Addendum No. 1
Page 1 of 2

TO: Prospective Bidders
SUBJECT: Addendum No. 1
PROJECT NAME: **Weitendorf Restroom Upgrades**
JJC PROJECT NO.: B25012

WEITENDORF RESTROOM UPGRADES
 WEITENDORF EDUCATIONAL CENTER
 17840 W. LARAWAY ROAD
 JOLIET, ILLINOIS

A1

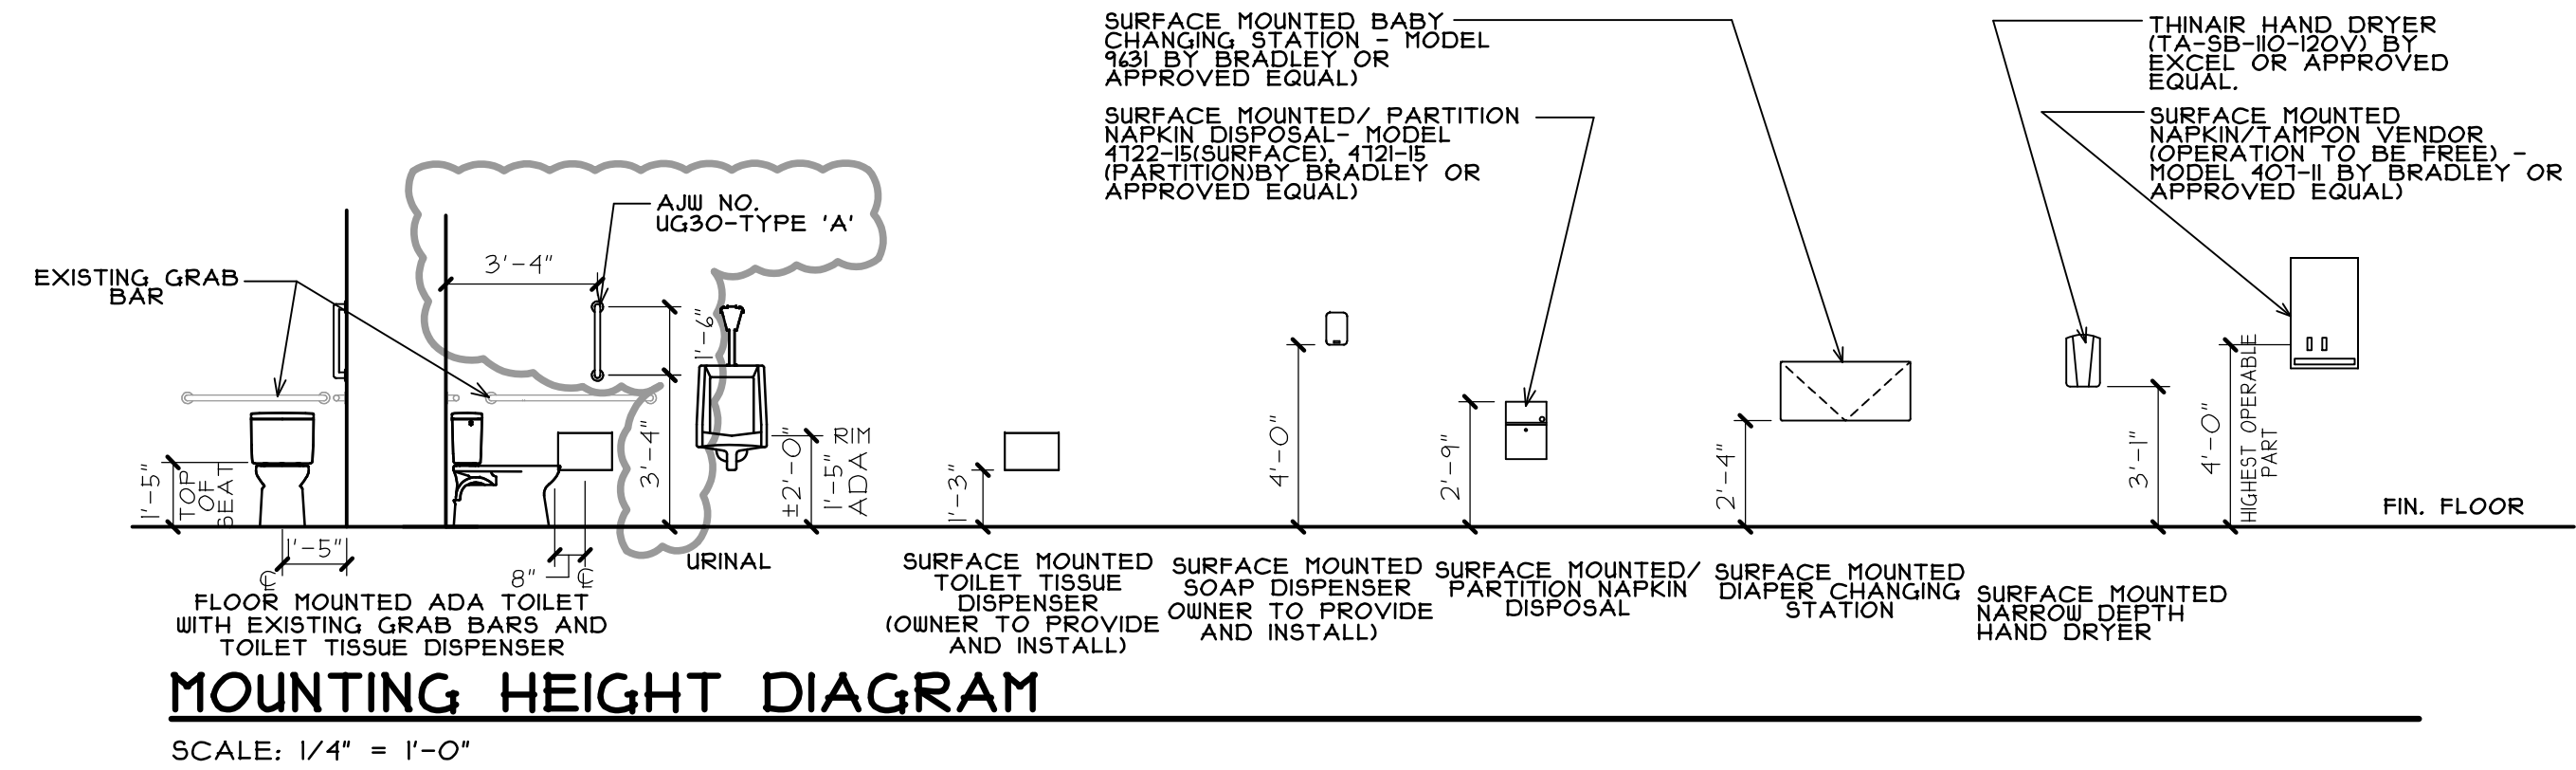
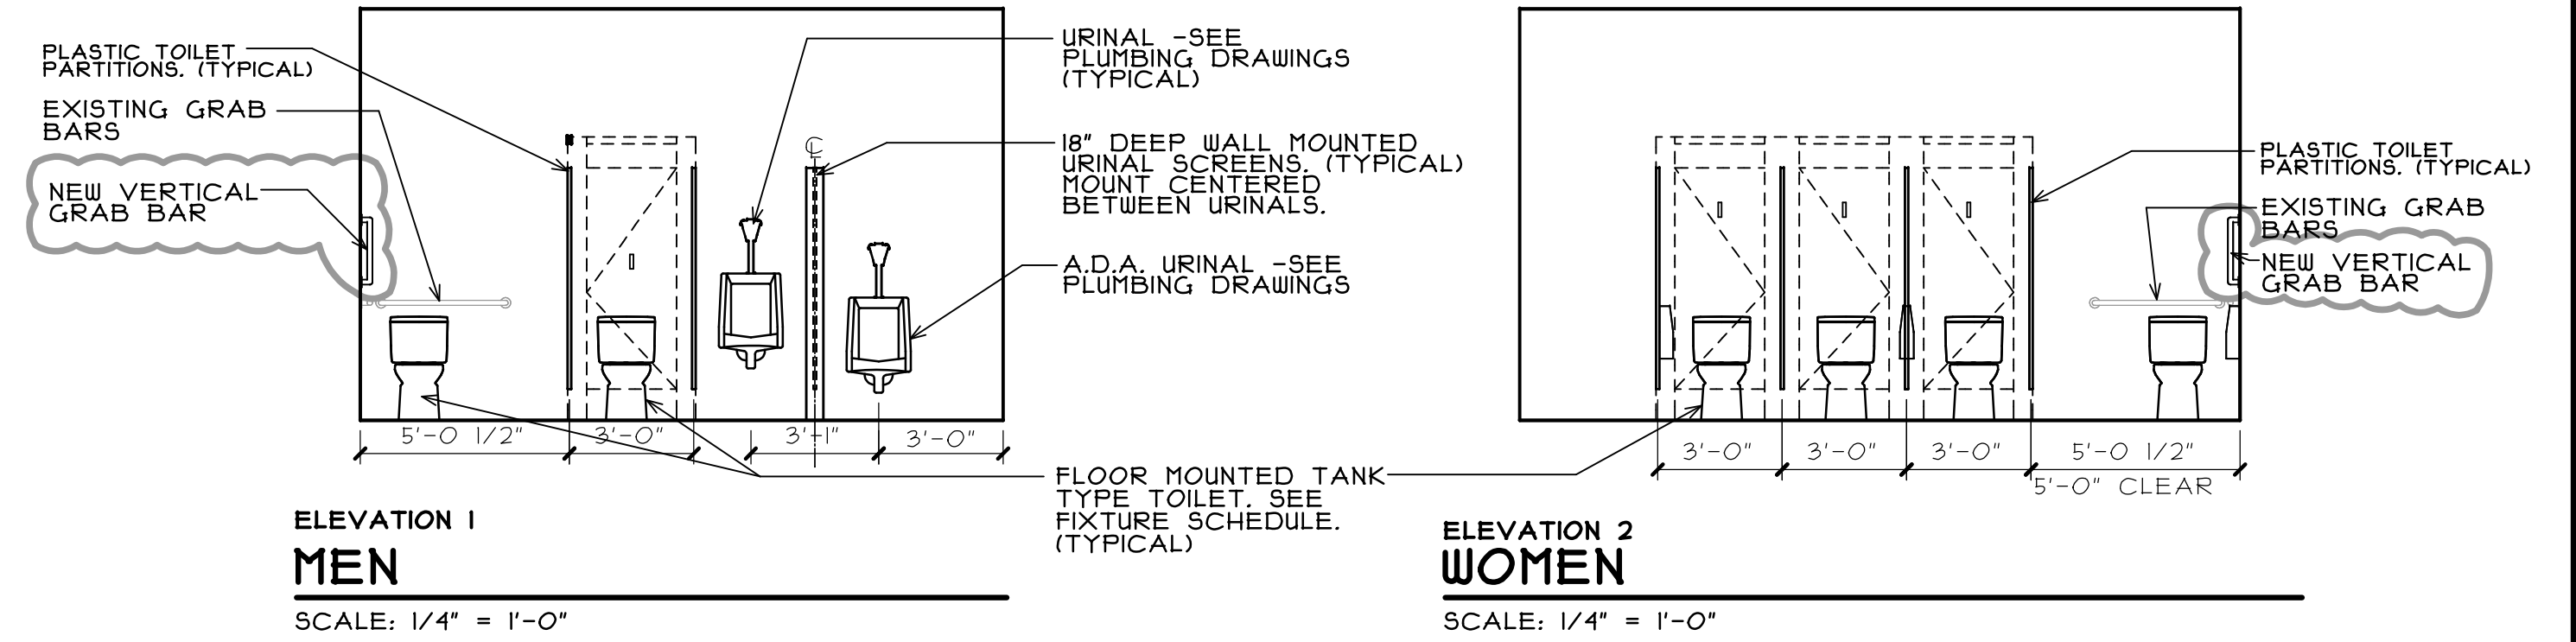
Drawing D1 calls out removing and replacing the textured ceiling panels next to the light fixtures that don't match the rest of the ceiling and on sheet A1 it is noted in General note F for infill these ceiling panels with new vinyl faced gypsum board panels that match existing. The manufacture and model is called out. This is typical of 5 panels only (3 in Womens and 2 in Mens), the remaining portion of ceiling to remain.

- 10. See attached revised drawing A1 that denotes the addition of a vertical grab bar in the ADA stalls.**
